Priority Projects Standing Advisory Committee Report

Referral No 2: Harvest Home Road, Wollert

23 September 2020

Figure 3 The proposal in context

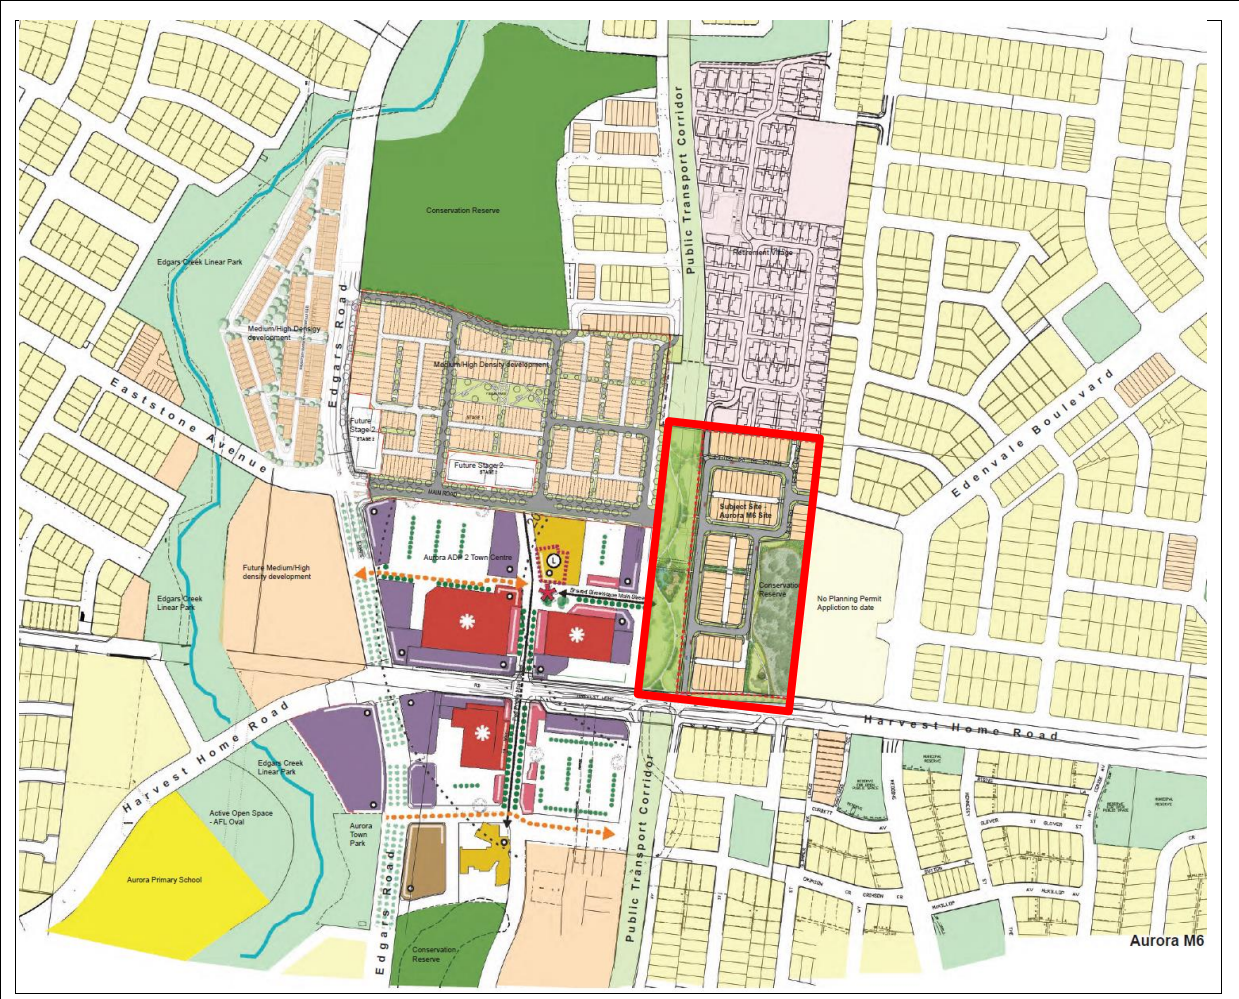
Council advised that the context plan for the Subject Land, detailing adjacent sites and natural features was never provided despite Council requesting this information in both its requests for further information.

At the round table discussion, Development Victoria tendered (Attachment A to its submissions) a site context plan prepared by Murphy Landscape Consultancy (reproduced at Figure 3) which shows the proposal in its setting within the Northern Town Centre and within the Development Plan area more broadly. Development Victoria submitted that the plan illustrates how the lot sizes and anticipated built form integrate will with the surrounding urban environment.

- The proposal integrates with the town centre in a fashion that is generally in accordance with the Development Plan.

Figure 4 The proposal and the Development Plan highlighting the pedestrian connection

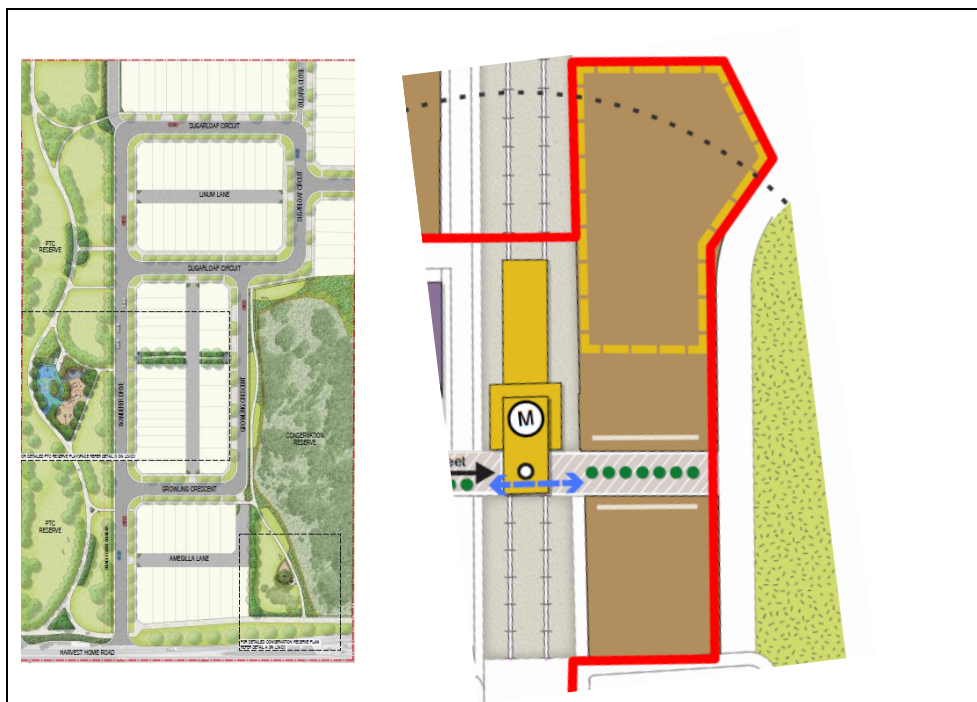
The Development Plan indicates a clear link between the future train station and the conservation reserve adjacent to the site. The proposal does not show the link as clear and instead indicates pedestrian movement through a linear passive open space area at the front of the development.

Council submitted that the pedestrian link needs to be consistent with Clause 56.06-1 (Integrated urban landscape objectives) and that the link needs to provide an opportunity to provide an attractive landscape setting in a public space that contributes to the character and identity of this new neighbourhood.

- The subdivision does not appropriately orient lots to support active street frontages where nominated in the Northern Town Centre plan.
- Street-based community interaction and pedestrian safety to the public space/pedestrian link has not been appropriately considered. This is demonstrated through lots siding on to the space and inadequate spatial consideration given to this in the overall layout.

- The shared space pedestrian link shown on the northern town centre plan is a link between the access road from Harvest Home Road to the station, and activity centre. The proposed development does not prevent this link being provided in the future on the rail reserve land. In this regard the proposal is generally in accordance with the Development Plan.
- With the moving of the road from the conservation reserve side of the subject land to the rail reserve side of the subject land there is a need to provide an appropriate connection to the conservation reserve and the Committee finds that the proposed pedestrian link does this.

Figure 6 Extract landscape master plan showing lots with side to conservation reserve

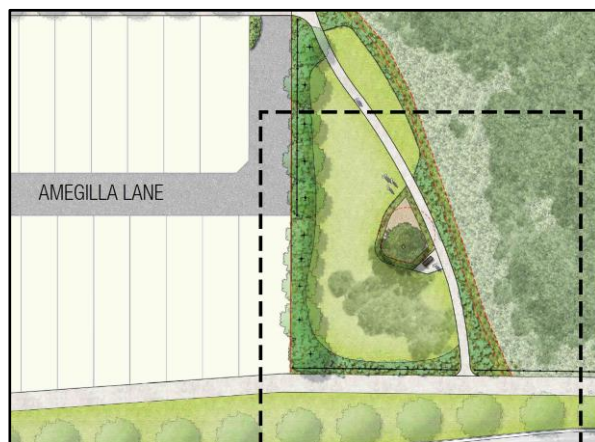
The issue is whether the lots proposed adjoining the conservation reserve are in accordance with the Development Plan.
